TECHNICAL SERVICE BULLETIN

Stuck In Park, "Service Vehicle Soon" Message In The IPC, Illuminated Powertrain Malfunction (Wrench) Indicator With DTC P07E6:71 Stored In The SOBDMC

26-2421

This bulletin supersedes 25-2622. Reason for update: Updated the Service Procedure to remove step related to connecting a battery charger, add Steps 7 and 29, add Figure 4, updated part list to include rear electric drive assembly stud bolts and nuts to secure the mass damper

Figure 4

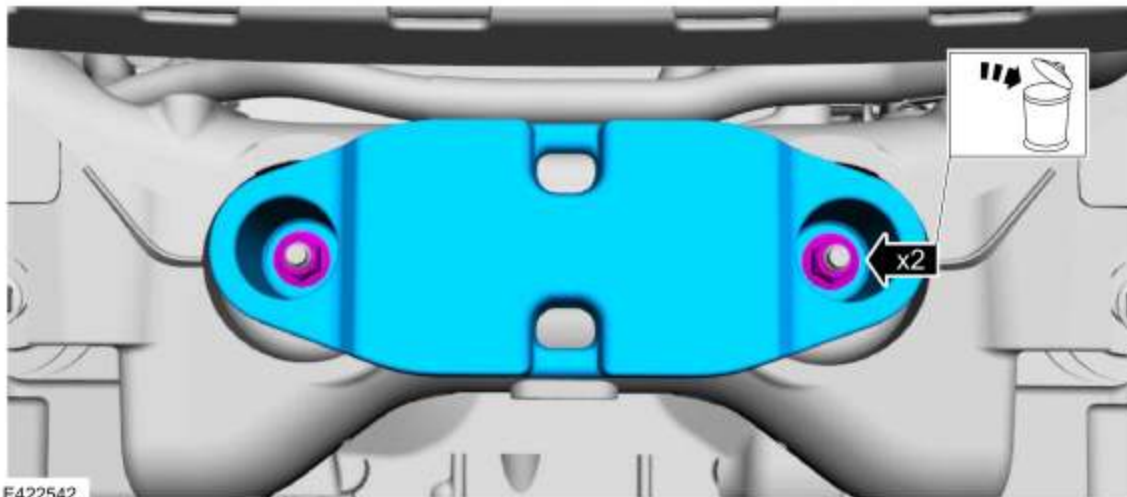
7. Is the vehicle equipped with a mass damper as shown in Figure 4?

(1). Yes - remove and discard the nuts, remove the mass damper.

(2). No - proceed to Step 8.

- 29.** If equipped, install the mass damper and the nuts. Tighten the nuts to 81 lb-ft (110 Nm).
- 30.** Remove the powertrain lift table and the wooden blocks.
- 31.** Position back the wire harness and install the nuts. Tighten the nuts to 97 lb-in (11 Nm). (Figure 24)
- Figure 24
